KMR.CDD.GaQ.1926.02

With reference to ^{his}~~their~~ application dated...20-2-26...with a
 plan for the proposal ^{huts}~~Building~~
~~additional~~ on plot No. 1A Survey Sheet No. 5-2
 Garden Quarter Mr. H. P. Pathak is informed that
 until the following requirements are complied with the plans cannot be
 passed.

PLAN SHOWING TEMPORARY SHEDS ON PLOT NO. 1A. SHEET NO. 12 E.2 GARDEN QUARTER, KARACHI. SCALE 8"=1"

With reference to ^{his} ~~their~~ application dated 23/10/25 with aplan for the proposal ^{Shed} ~~Building~~ ^{additional} on plot No. 1A Survey Sheet No. E.2Garden Quarter Mrs. { Abdul Hussain Musabhoj
Abdul Rahim Jazabaly
Yusufali M. Bokkmanji } are informed that

PLAN SHOWING TEMPORARY
SHEDS ON PLOT NO. 1A. SHEET NO. 12 E 2
GARDEN QUARTER, KARACHI.
SCALE 8"=1"

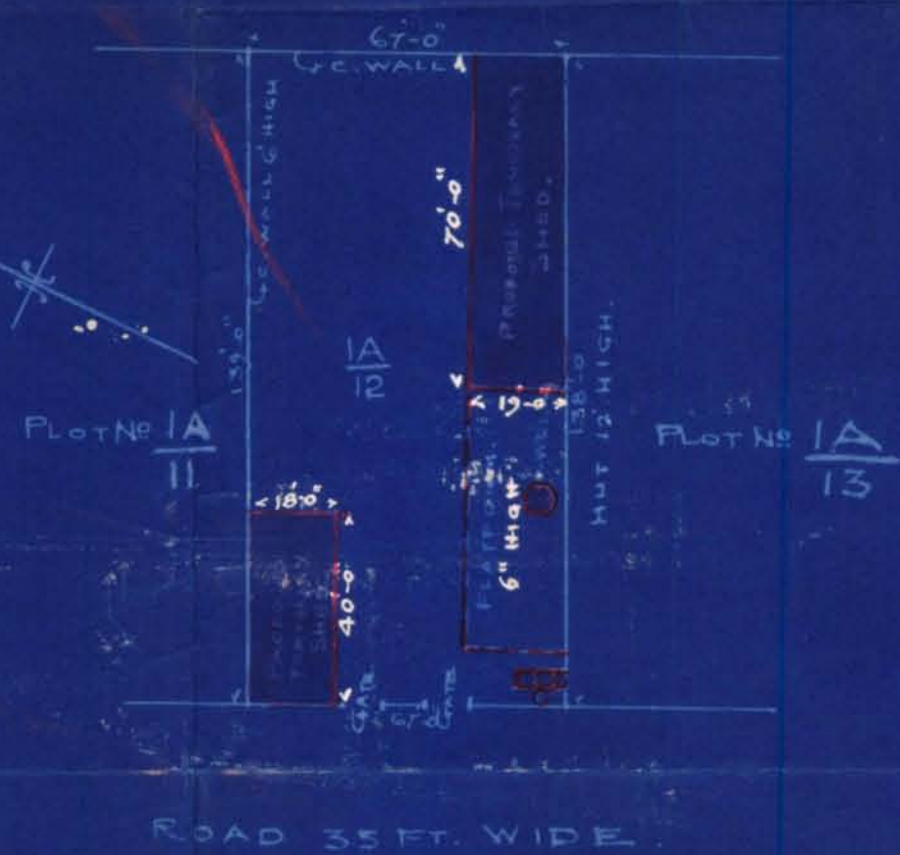
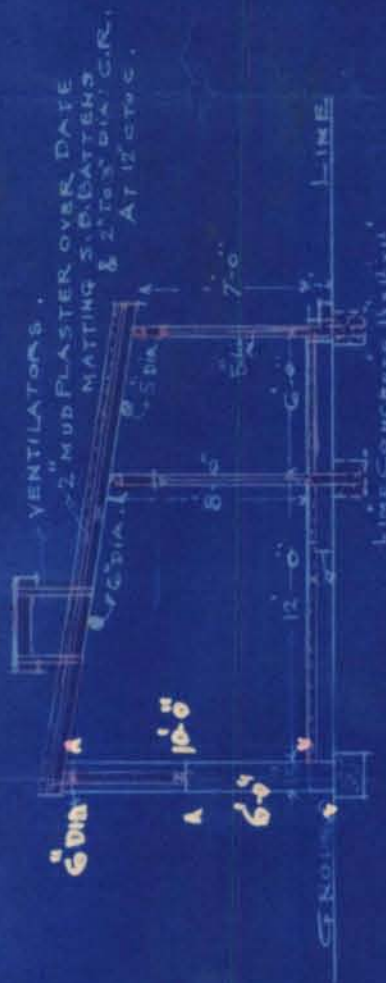
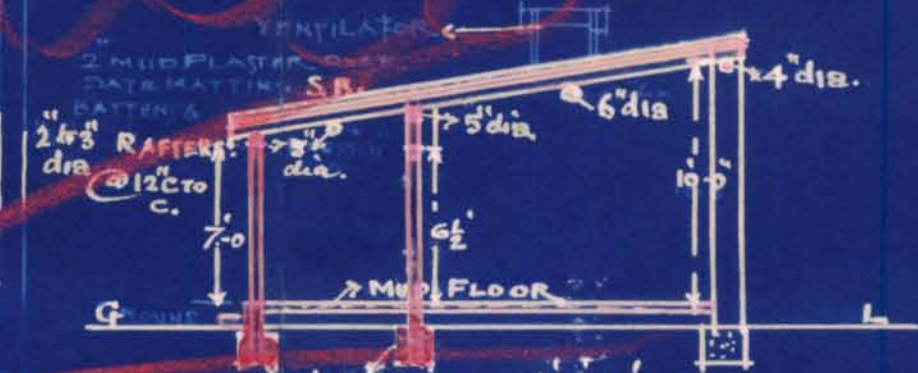
- (1) Middle partition wall must be a pucca masonry wall
- (2) Height of flint should be 2 ft.
- (3) Clear height of room should be 10 ft.
- (4) There should be 3 privies
- (5) Depth of foundation must be given
- (6)
- (7)
- (8)
- (9)

*So called sheds are not
living rooms. Rooms have
no through ventilation, no
adequate lighting and
flooring cannot be put*

(1) The building is a temporary structure
and the partition walls are of ~~corrugated~~
sheets which are of ~~inferior~~ flammable
material.

2. The temporary structures ~~has~~ in
most cases ~~plinth~~ of 1 foot.

Clear height of roofs required
by Municipal Building Bye Law
page 96 para 234 (1) is only 8' feet
while it is provided $8\frac{1}{2}$ feet minimum.

4. For ~~each~~ tenements two
privies are now provided.

5. Depth of foundations are already
given in the plan.
